Determination 2010/029

The issuing of a notice to fix and the code-compliance of roof trusses for a house addition located at 80 Atkinson Road, Titirangi, Auckland

Figure 1: the truss layout for the addition

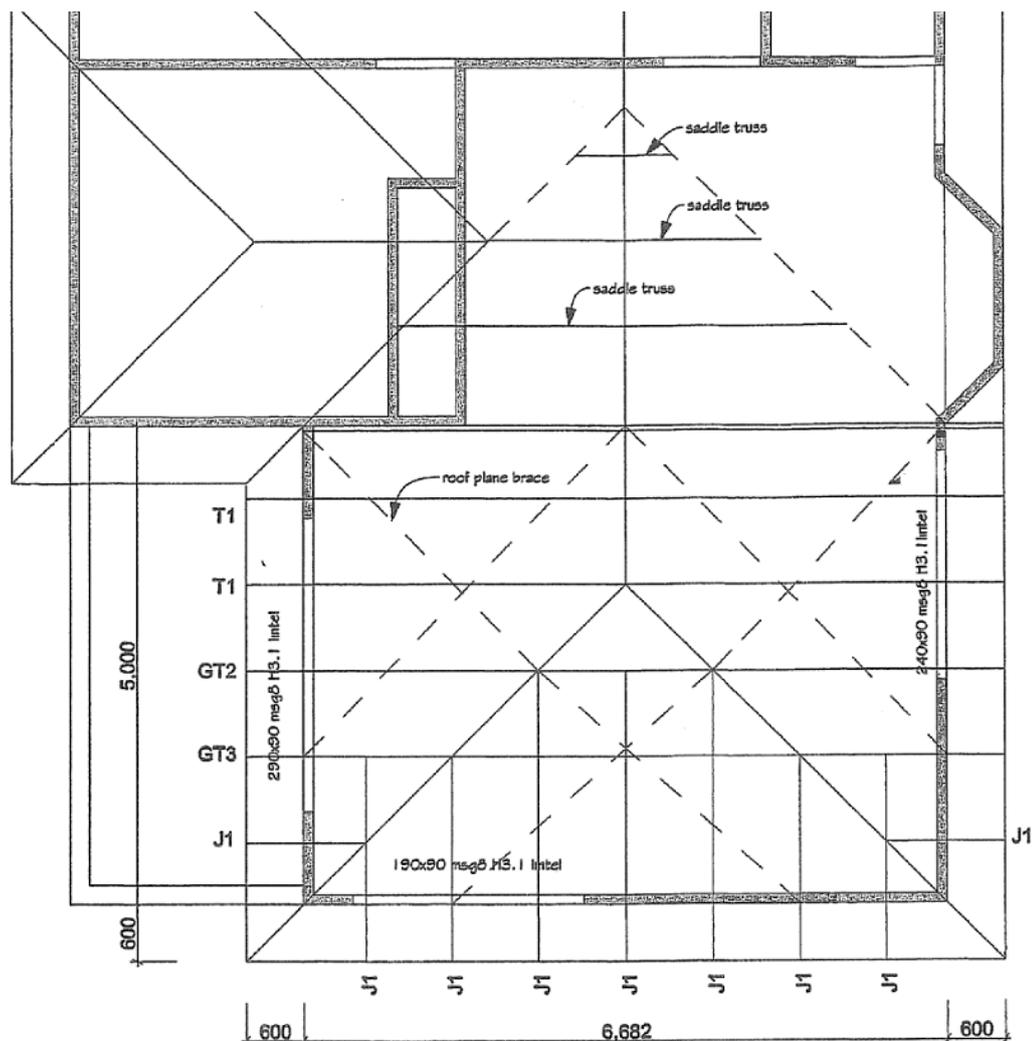
- 5.2.2 The officer noted that in general deflection due to creep is of far more concern than an increase in immediate deflection between MSG8 and MSG6 timber due to lower stiffness properties. In this case, the deflection of the trusses in question was found to be very small. The design information showed 1.2mm truss deflections at the bottom chord node points under dead load. This was considered insignificant when compared with the suggested serviceability limit state criteria of 13mm to 18mm for this free span load case. The officer noted that:

- significantly less than the distortion limit in the transverse direction associated with a stiff adjacent double truss (3.5 mm). The trusses were installed dry however this distortion limit (of 3.5 mm) would still not be reached even if the moisture content of the truss timbers were more than 25% for 12 months or more.

- Based on this criterion, the maximum free span truss deflection allowed, and the corresponding design deflection based on the re-graded NLB timber properties, are:

- (i) 13 to 22mm under dead load only, depending on the condition being guarded against. (Design deflection – 1.3mm and 2.2mm respectively).
 - (ii) 32mm under dead load plus part live or wind uplift load. Accordingly compliance was achieved. (Design deflection – 1.8mm).

- (iii) 32mm under dead load plus downward wind load (4.3mm).
- Checks on the deflection of the individual chord members with the concentrated live loads specified in AS/NZS 1170.0 at mid-span, indicated that the deflection was at the suggested upper limit of Table C1 of the Standard.

- Deflection of the truss top chord overhang at the eaves is critical but it is normal industry practice to assume some load spread by crossing members such as fascia boards. Documentation received from the software designer indicates that the deflection between node points was set by the truss manufacturer at 7mm.

- A check of the transverse distortion between the short span double truss and the first full span truss was done. The calculated deflection of this first adjacent full span truss under dead load based on the re-graded NLB properties is 1.3 mm and the deflection relative to the adjacent double truss, because of the small shorter span double truss deflection and the load sharing due to the crossing ceiling battens and purlins, is not likely to exceed 1mm.

5.2.4 The report concluded that the trusses in question met the strength requirements of NZS 3603¹⁰ and the serviceability requirements of AS/NZS 1170.0. As both these documents are cited in B1/VM1 as a means of compliance, the trusses were considered to be code-compliant. However, it was appreciated that the level of confidence associated with the properties determined for the re-graded NLB timber is less than that for MSG8. Properties of the re-graded NLB timber have been determined with a confidence of 75% whereas the timber processor's MSG8 is produced with a confidence level between 90 and 95%.

- 7.2.1 Based on the officer's comments and the specific engineering analysis founded on the statistically determined properties of the re-graded NLB timber used, I am prepared to accept that the trusses of the house addition comply with Clause B1 of the Building Code.
- 7.2.2 While I have concluded that these particular trusses are code-compliant, I also note the application of the methods used to establish code-compliance of the NLB timbers in this instance. The conclusions reached in this determination may assist, and be helpful to, building consent authorities in other circumstances to assess the structural performance of this specific population of re-graded NLB timber by using specific engineering analysis to show code-compliance. However, the tests and methods used in this determination will not automatically apply to other similar or future scenarios.

- the roof trusses of the house addition comply with Clause B1 of the Building Code
- the decision of the authority to issue a notice to fix be reversed.
